Re: Turkey Point Unit 3  
Docket No. 50-250  
Inservice Inspection Plan - Fifth Inspection Interval  
Unit 3 Relief Request No. 1 – Response to Request for Additional Information

Turkey Point Unit 3  
Fifth Inspection Interval  
Relief Request No. 1  
Response to Request for Additional Information

Figure 1: A216 Gr. WCC Fracture Toughness, K<sub>IC</sub> [4]

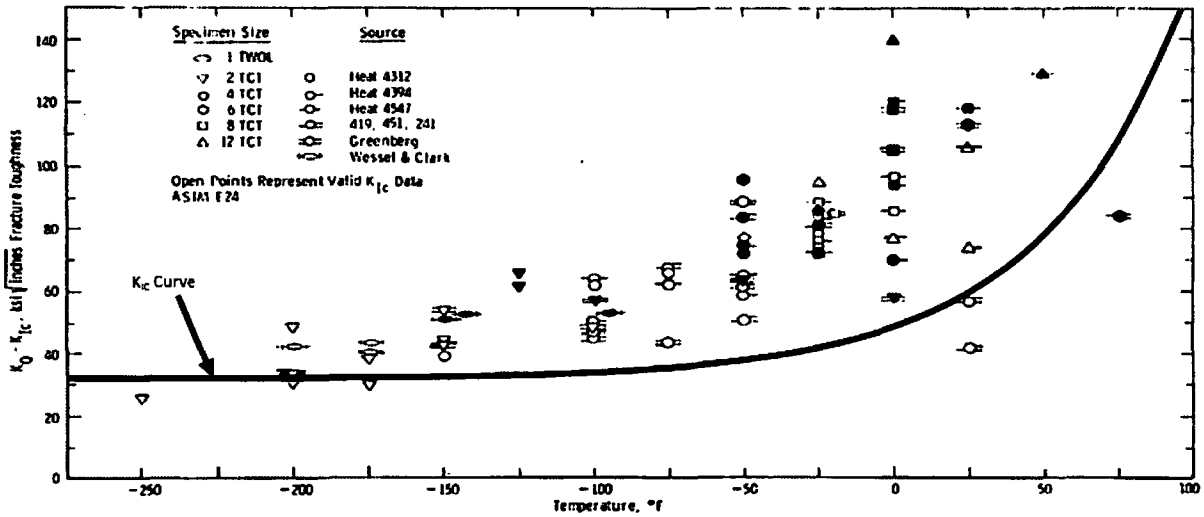
- b. Demonstrate that the material resistance to fracture (J-R curve) of the Turkey Point, Unit 3 pressurizer bottom head is equal to or greater than the material resistance to fracture used in the crack stability evaluations in Reference 1 and 2.

The pressurizer head is fabricated from SA-216 Gr. WCC cast steel, and the ASME Code KIC curve is directly applicable to this material. Over the years, a great deal of fracture toughness information has been obtained regarding this material, and a figure has been prepared to summarize the data as compared to the ASME Code reference KIC curve; see Figure 1. The fracture toughness was determined for nine heats of material, whose results are plotted [Reference 4]. Sufficient Charpy information was also obtained on these heats of material, and the NUREG-0800 method was used to estimate RTNDT, which was found to be 10°F for each heat. Figure 1 shows that the KIC curve is clearly appropriate for this steel.

Per [1], the KIC allowable for the pressurizer lower head (heater sleeves) at end of cooldown is 25.0 ksi- $\sqrt{\text{in}}$ , with RTNDT = 30°F. The end of cooldown is 70°F, conservatively using the RTNDT of 30°F,  $T - \text{RTNDT} = 40^\circ\text{F}$ . The KIC at 40°F from Figure 1 is approximately 70 ksi- $\sqrt{\text{in}}$ , which is much higher than the KIC = 25.0 ksi- $\sqrt{\text{in}}$  used in [1]. Therefore, it is conservative to compare the CE stability evaluation in [1] to the Turkey Point plant.
